#### HISTORIC AND DESIGN REVIEW COMMISSION

**HDRC CASE NO:** 2017-419

**ADDRESS:** 715 GRANT AVE

**TYPE OF WORK:** Construction of four, 2-story single family units

SITE PLAN
SCALE: 1/4"=1'-0"

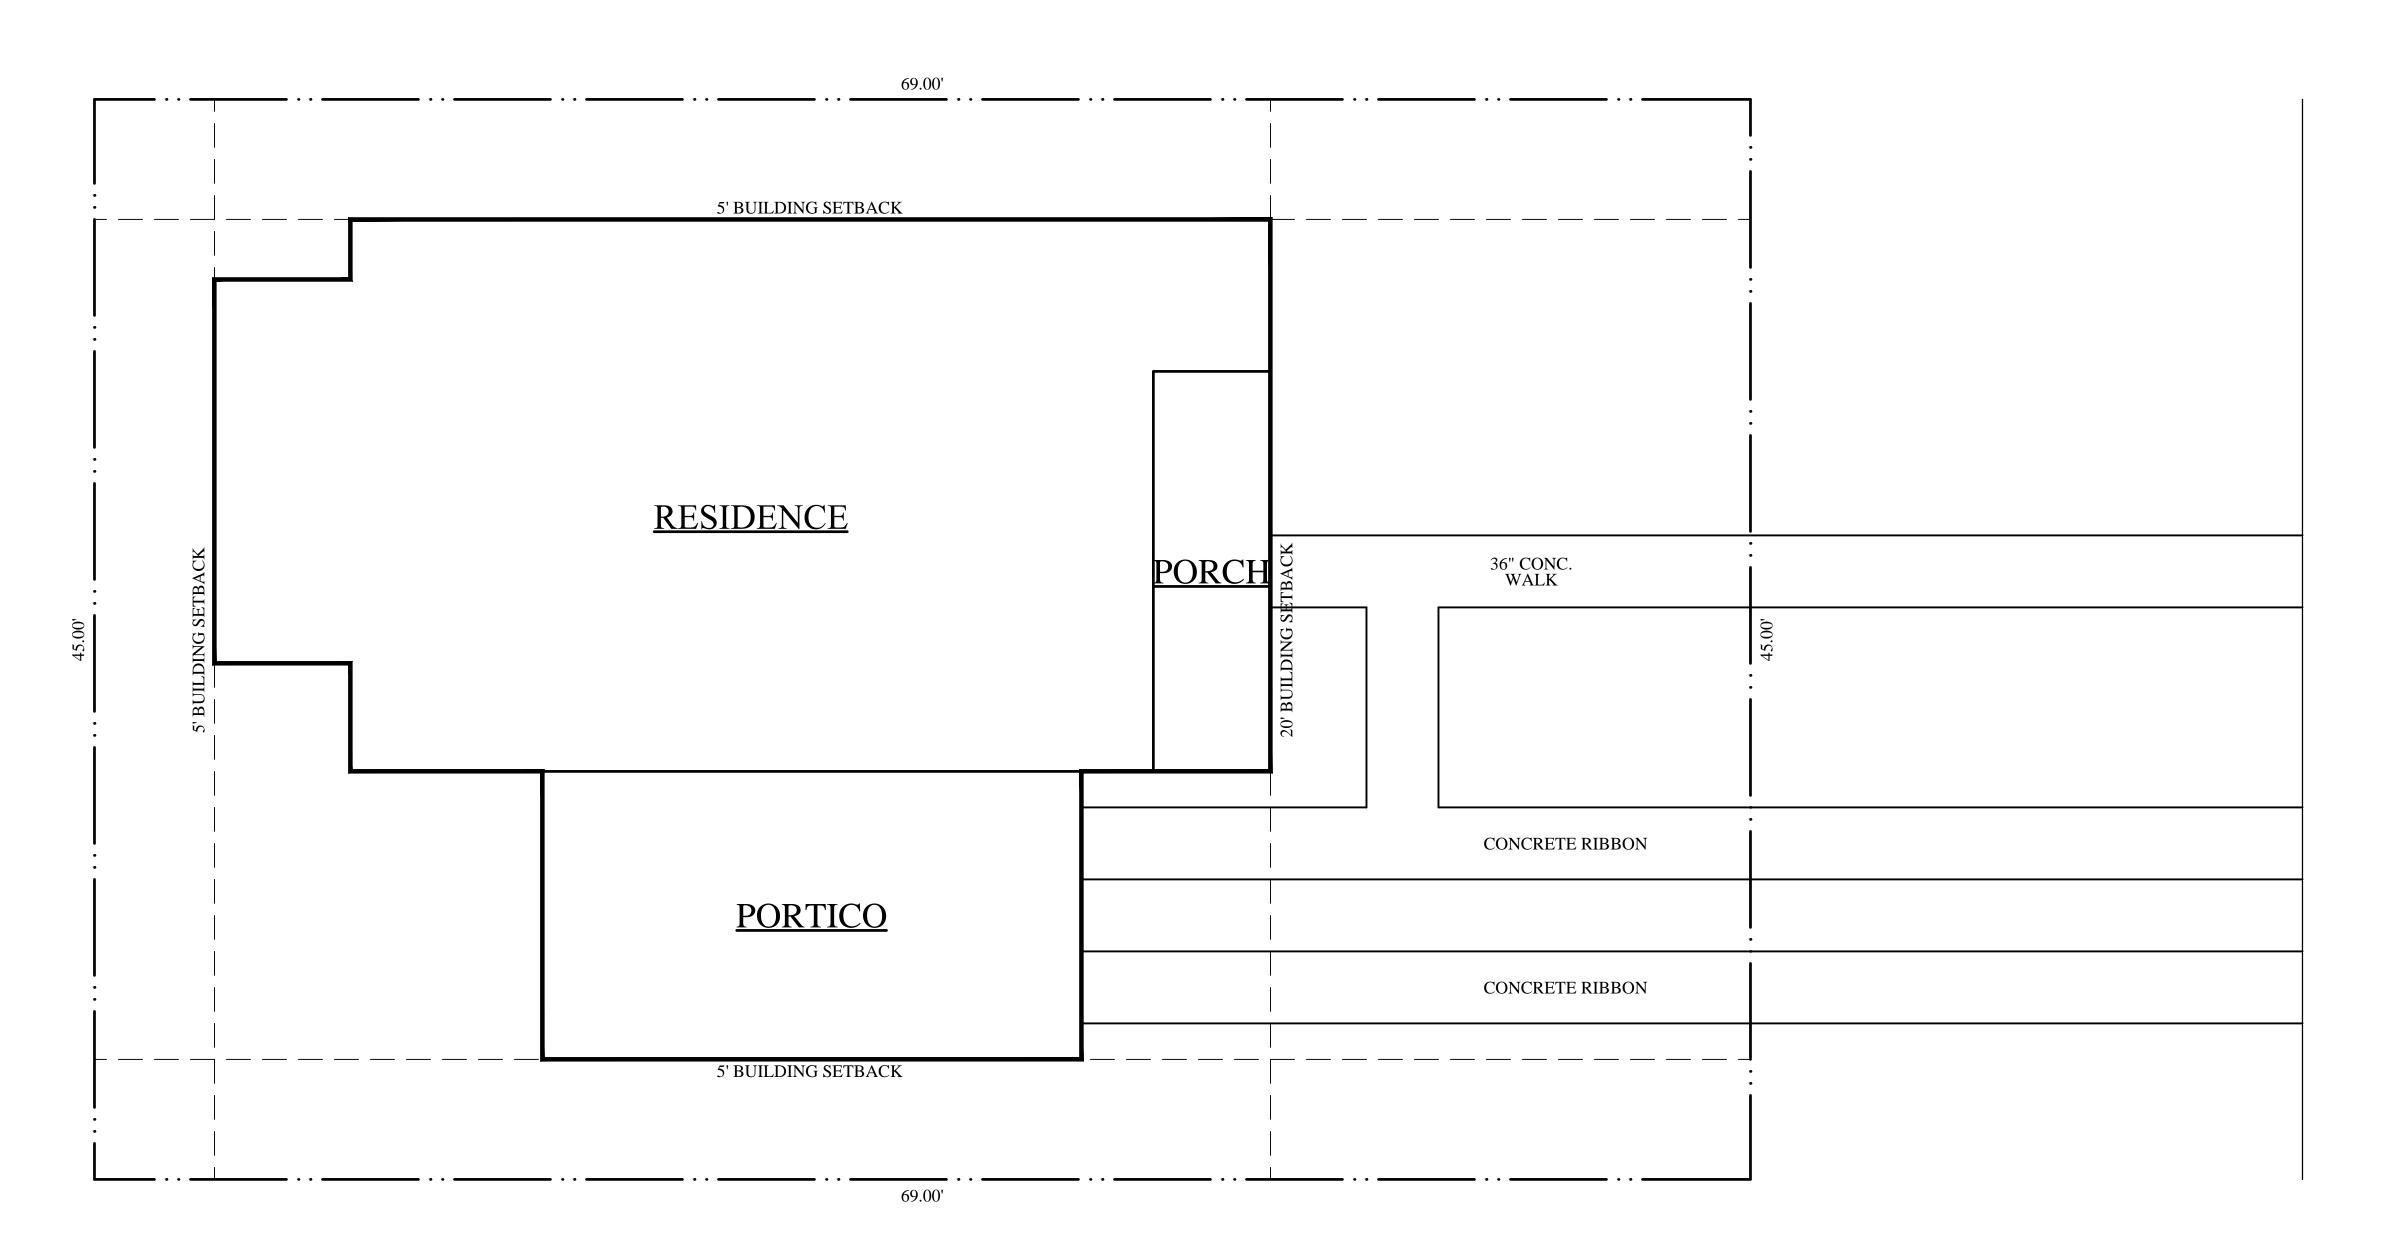
- b. LOT COVERAGE Many lots in the vicinity feature a primary residential structure that fronts a primary street with one or more accessory structures toward the rear of the site. According to the Historic Design Guidelines, new construction should be consistent with adjacent historic buildings in terms of the building to lot ratio. Building footprints should be limited to no more than 50 percent of the total lot area, unless adjacent historic buildings establish a precedent with a greater building to lot ratio. For each individual lot, impervious coverage ranges from 38% to 46.6%. There are several historic structures along the blocks of W Magnolia and W Mistletoe that met or exceed these percentages. Staff finds the proposal generally consistent with the Guidelines.

- c. SETBACKS & ORIENTATION According to the Guidelines for New Construction, the front facades of new buildings are to align with front facades of adjacent buildings where a consistent setback has been established along the street frontage. Additionally, the orientation of new construction should be consistent with the historic examples found on the block. Per the applicant's proposed site plan, each structure will be set back 20 feet from the property line. Two of the structures will be oriented towards W Magnolia Ave and two will be oriented towards Grant Ave. While the former historic landmark structure was one single family home oriented towards W Magnolia Ave, the orientation of each unit is generally consistent with established patterns on the block, as corner homes are oriented towards W Magnolia and mid-block homes are oriented towards Grant. Staff finds the setbacks and orientation generally consistent, but has not seen a site plan that places each of the proposed units in context with the surrounding setbacks of the existing structures on the block. The proposed development pattern also has no historic precedent. More variation in building setbacks among structures would be appropriate to help distinguish each structure as an individual unit, which is more consistent with development patterns in the vicinity.

- n. SIDEWALK The applicant has indicated their plan to install sidewalks facing Grant Ave and W Magnolia Ave. However, these have not been formally indicated on the site plan. The proposed sidewalks should relate to those found historically in the district in terms of location, width, and material.

- o. DRIVEWAYS On both the east and west side of the lot, the applicant has proposed to install ribbon driveways. Two driveways will be accessed from W Magnolia Ave, and two driveways will be accessed from an existing unpaved alley off of Grant Ave. The applicant has stated their intent to pave the alley for improved access. The Guidelines for Site Elements note that driveways should relate to historic driveways in the district and should not exceed (10) feet in width. The proposed driveways are consistent with the Guidelines in terms of configuration, but their widths are not provided on the submitted site plans.

- b. LANDSCAPING The applicant has noted the location of walkways and driveways on the site plan; however, a detailed landscaping plan should be submitted to staff prior to submitting for final approval.

- The elevations should include surrounding existing structures to scale and include the proposed porticos.
- 2. That the applicant provides a site plan that places the proposed units in context with neighboring structures on the block as noted in finding c. The site plan should indicate all existing setbacks as well as the proposed setbacks of the new units. The applicant should also explore ways to slightly modify the setbacks to add streetscape variation, which is more consistent with development patterns in the district.

- 8. That the applicant submits a comprehensive landscaping and hardscaping plan with all appropriate dimensions indicated, including ribbon driveway width and length, pedestrian walkway width and length, the location of the proposed sidewalk, and building setbacks.

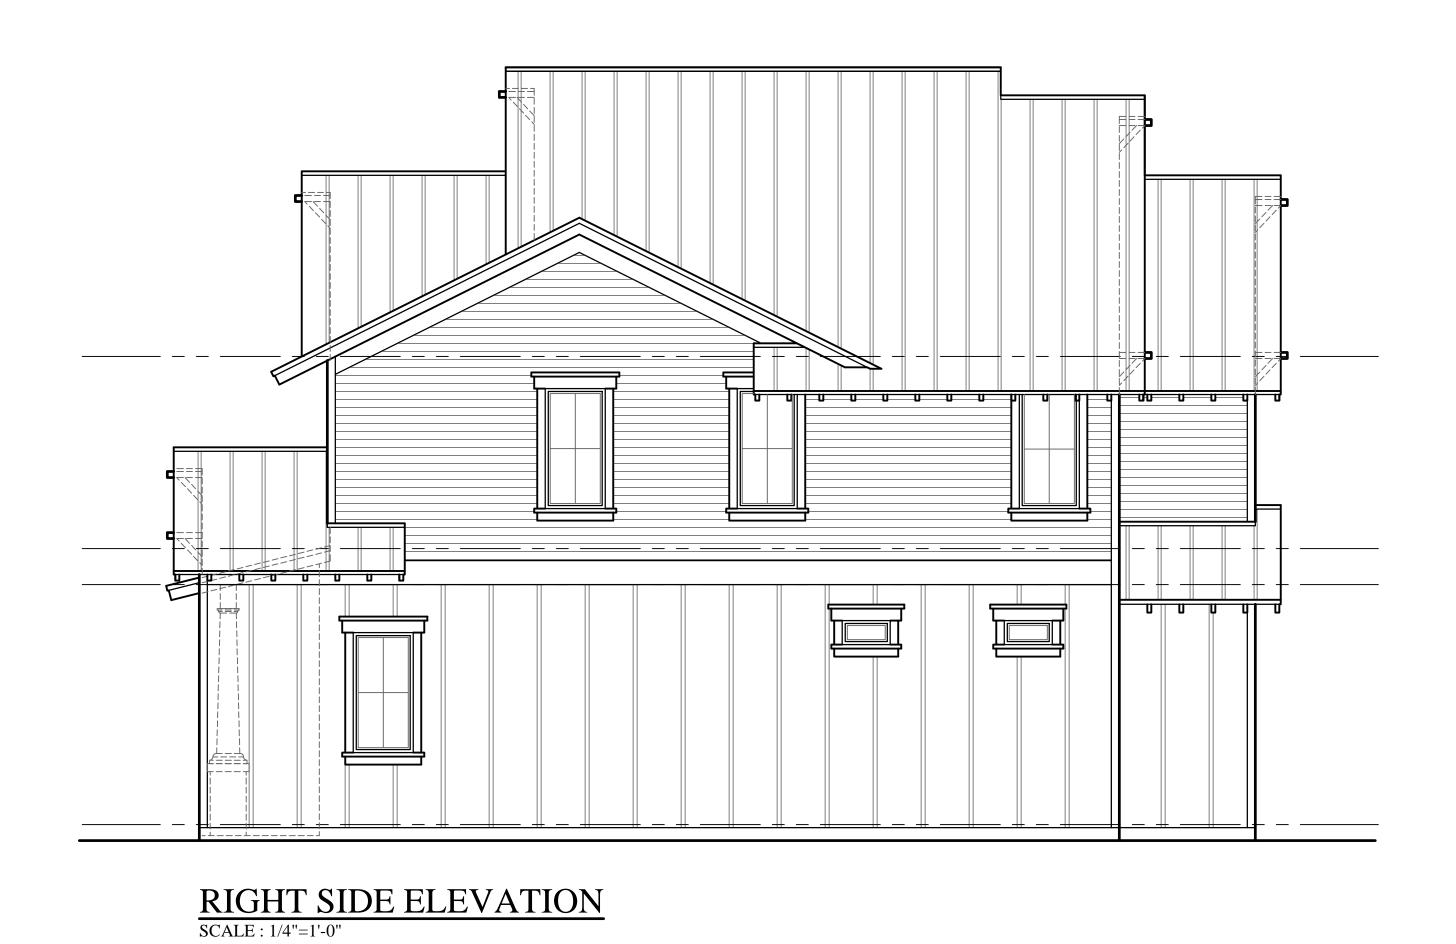
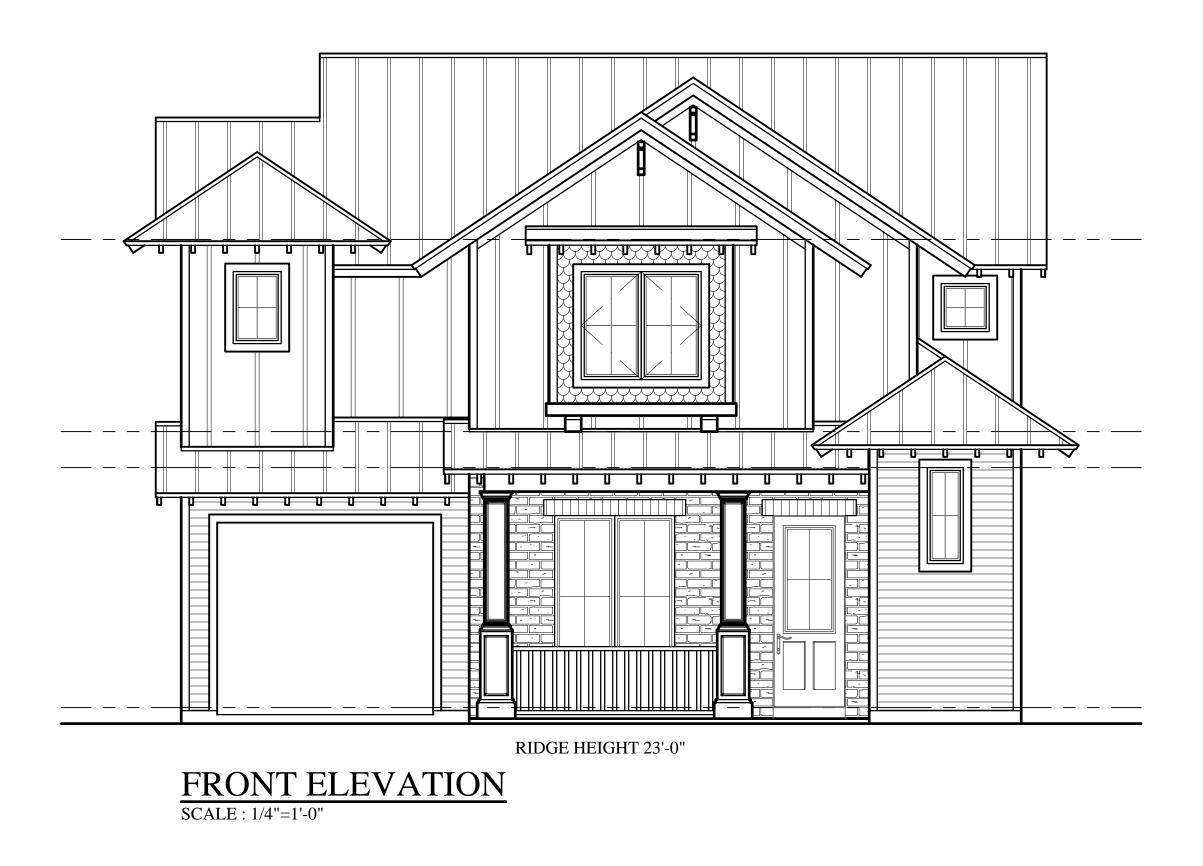
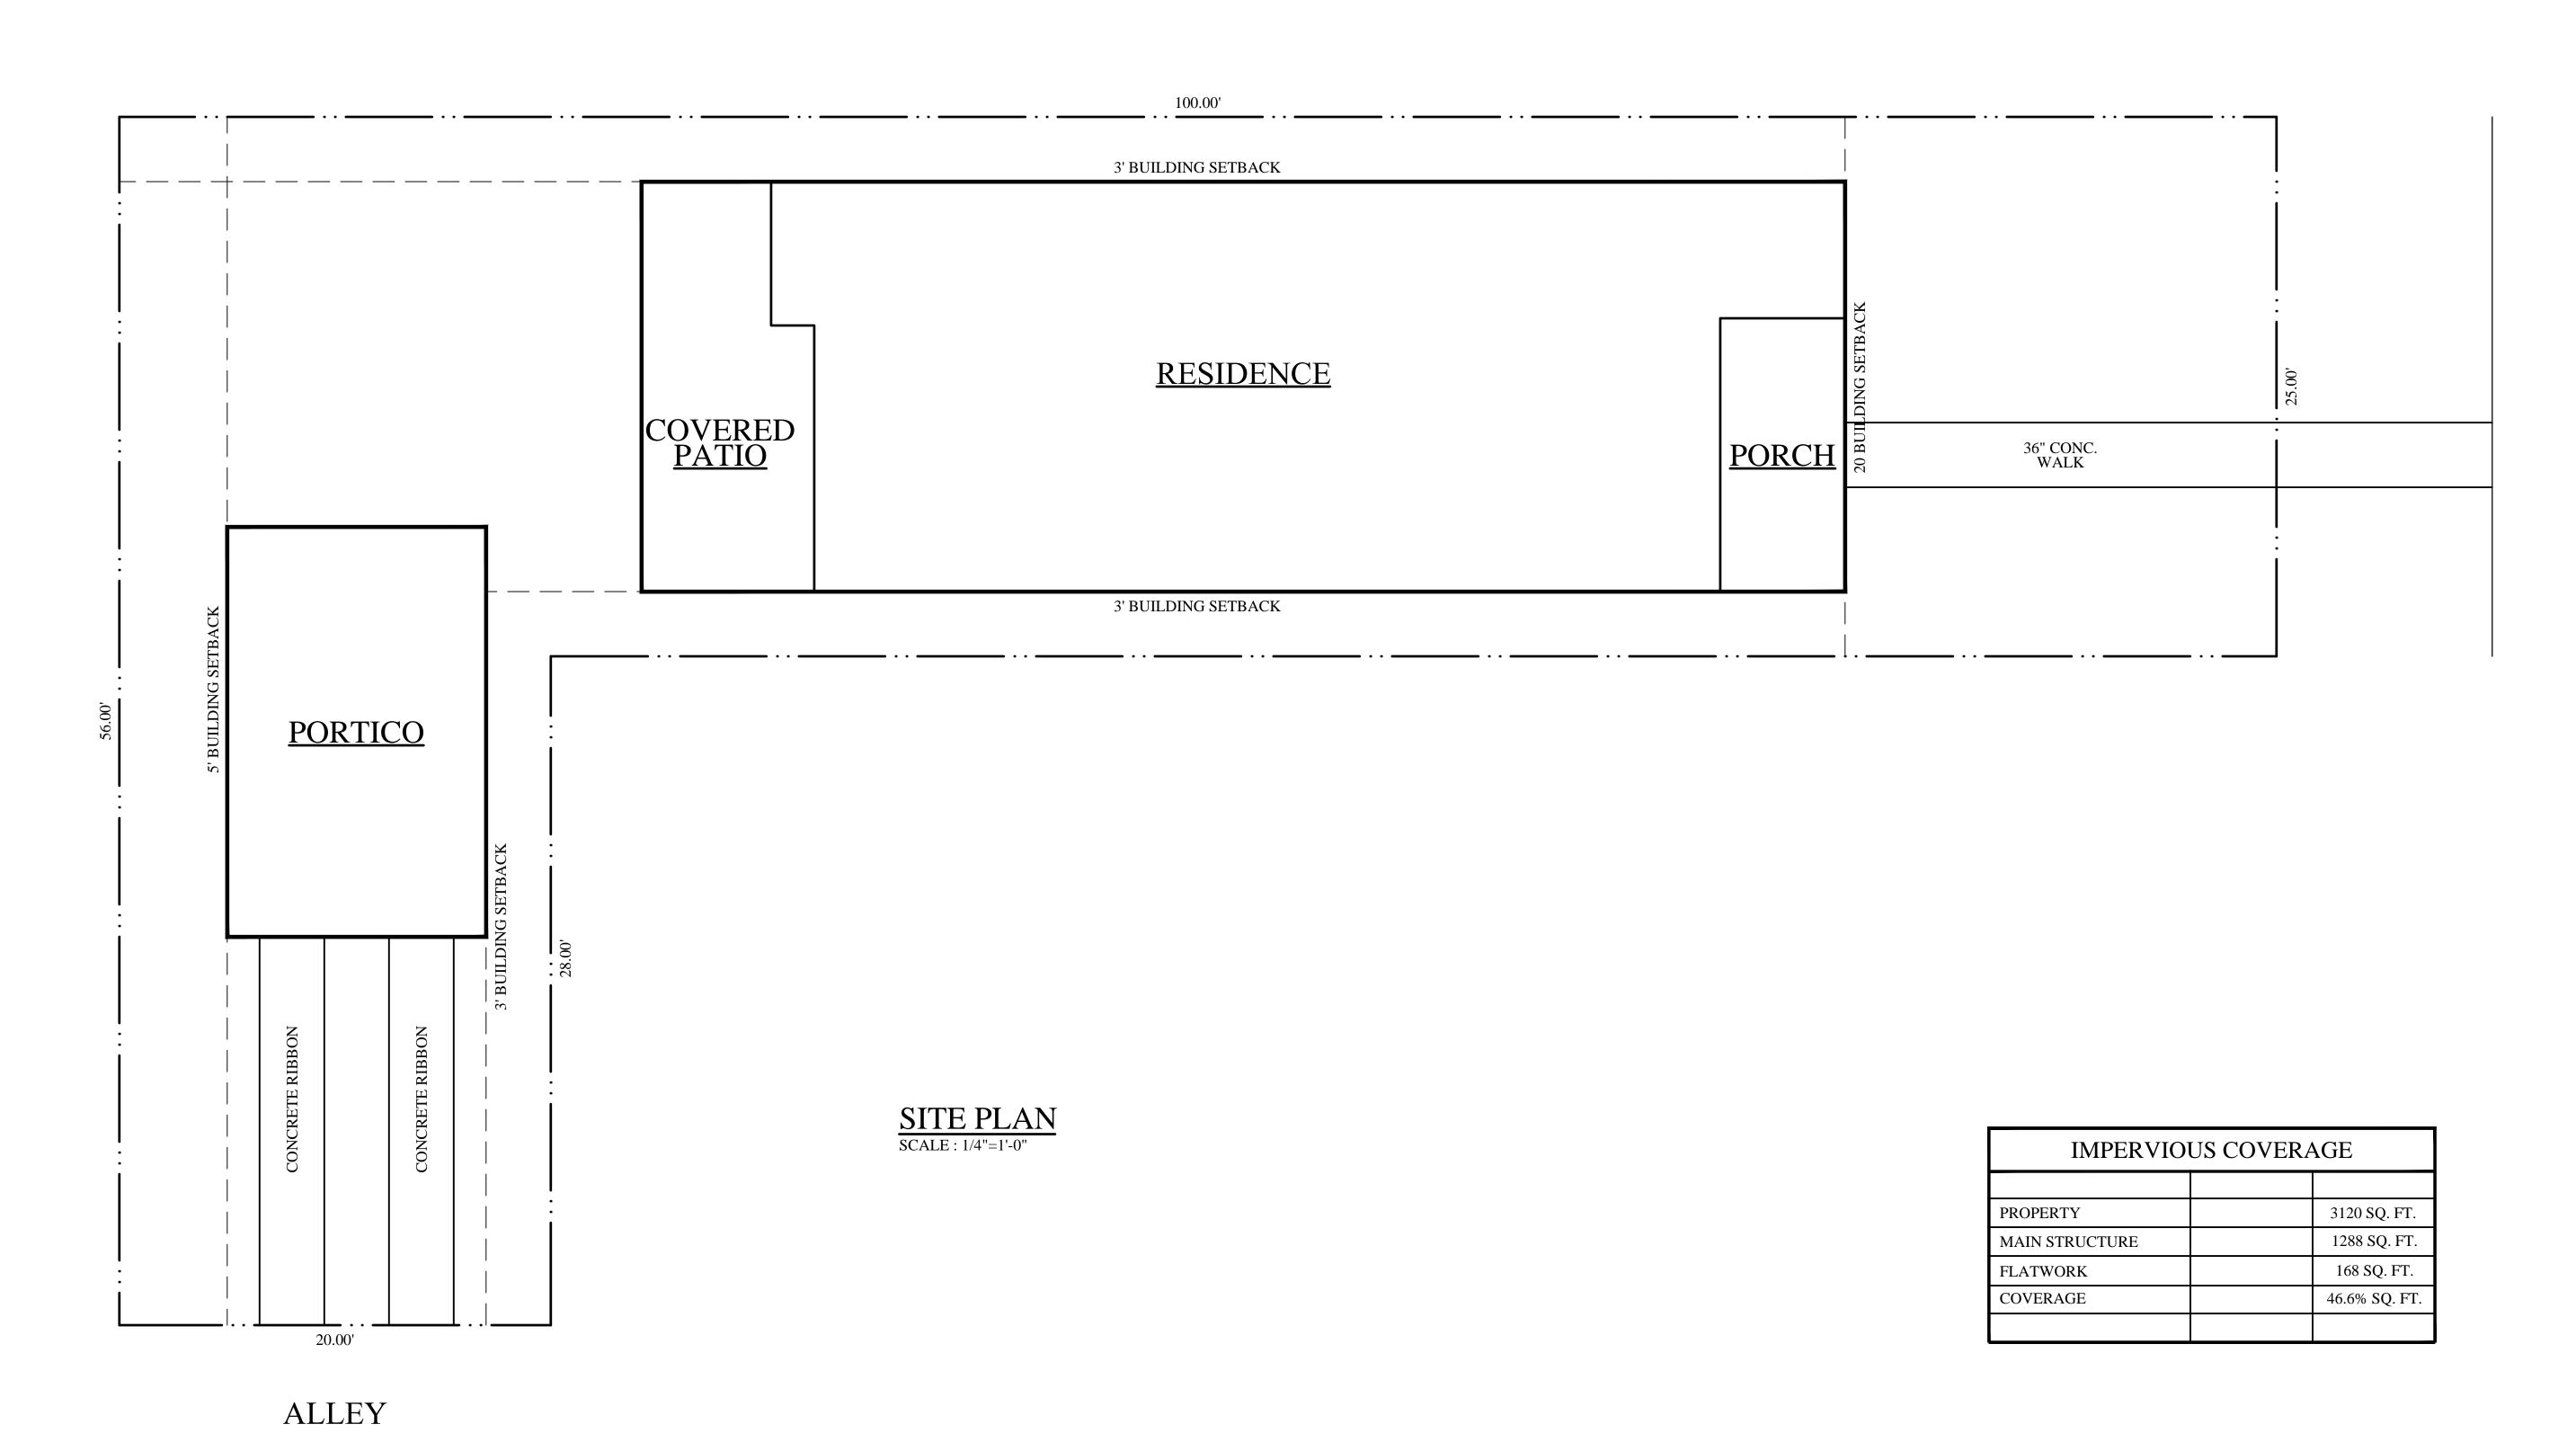
- e. SCALE & MASS The applicant has proposed four individual single family structures. The ridge lines, as indicated on the submitted elevations, range from 23'-0" (Lot-2), 23'-2" (Lot-3), 31'-6" (Lot-1), to 32'-6" (Lot-4). The scale of the individual buildings is generally consistent with the Guidelines.

- g. ROOF FORM The Historic Design Guidelines for New Construction state that new structures should incorporate roof forms, including pitch, overhangs, and orientation, that are consistent with those predominantly found on the block. The applicant has proposed to incorporate both gabled and hipped roofs into the four units, as well as exposed eave rafters, bracketing, vergeboards, and gable details to include scalloped shingles and false timbering. Gabled and hipped roofs are found throughout the Beacon Hill Neighborhood Conservation District; however, there are several variations on each individual unit, including both steep and low-sloped gables, combinations of multiple hips and gables, multiple ridgelines, and varying eave or vergeboard detailing. Lot-2 has gables that intersect, asymmetrical vergeboards, and hips that wrap around wall planes. Lot-4 features a front elevation with three steeply-pitched gables on the second floor with flaring vergeboards, and gables on the first floor with a drastically lower slope. The rear elevation of this unit contains two gables on the second floor with gable geometry that does not line up between the two forms. These roof forms are a departure from historic precedents in the district and incorporate an amalgam of historic styles, including Tudor, Queen Anne, Craftsman, and Prairie. Staff finds the number of roof forms and projections to be inconsistent with the Guidelines and historic precedents.

- h. WINDOW & DOOR OPENINGS According to the Historic Design Guidelines for New Construction, window openings with a similar proportion of wall to window as compared to nearby historic facades should be incorporated. Similarity is defined by windows that are no larger than 25% in size and vary no more than 10% in

height to width ratio from adjacent historic facades. The applicant has proposed several window and door openings that generally feature sizes that are found on historic structures. However, each unit contains several small fixed windows that are not consistent with the OHP Window Policy Document or historic fenestration precedents in the district. All proposed window detailing can be modified to relate closer to historic examples, such as the use of approximately six inches of separation between double windows. Each window should be inset at least two (2) inches within walls to ensure that a proper façade depth is maintained.

- 5. That the applicant simplifies the overall massing and configuration of the proposed roof forms to be more consistent with the historic roofs found in the district as noted in finding h.

- 7. That the applicant proposes a fenestration pattern and window opening proportions that are more consistent with the Guidelines and the OHP Window Policy document as noted in finding h.
